CHAPTER 4

Corrections and Additions

Occidental College . 205278

Figure 2.2
Existing Building Map

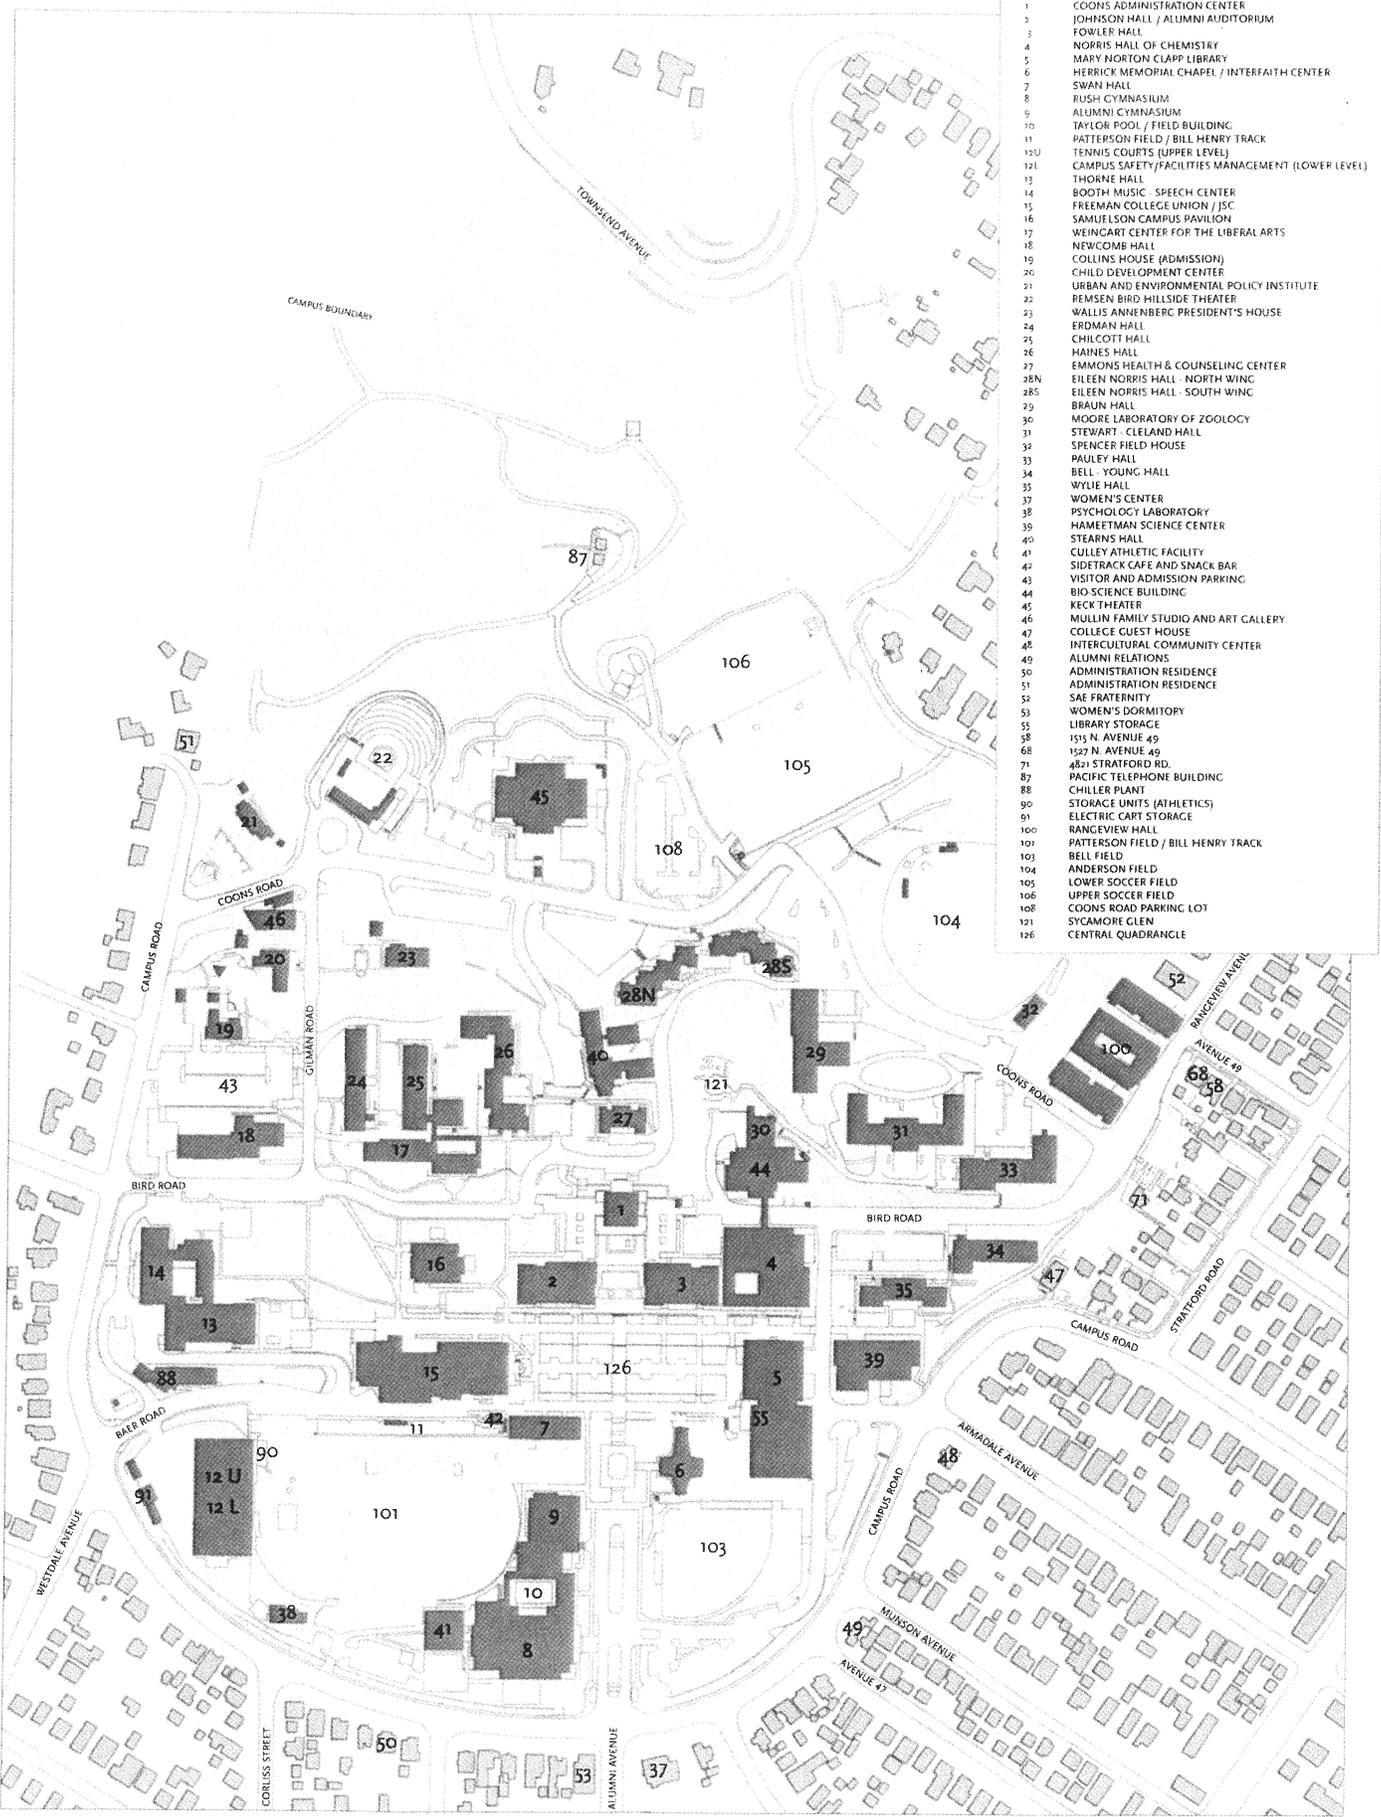
Figure 2.2 on page 2-3 is replaced with a revised Figure 2.2 (additional buildings were labeled) following.
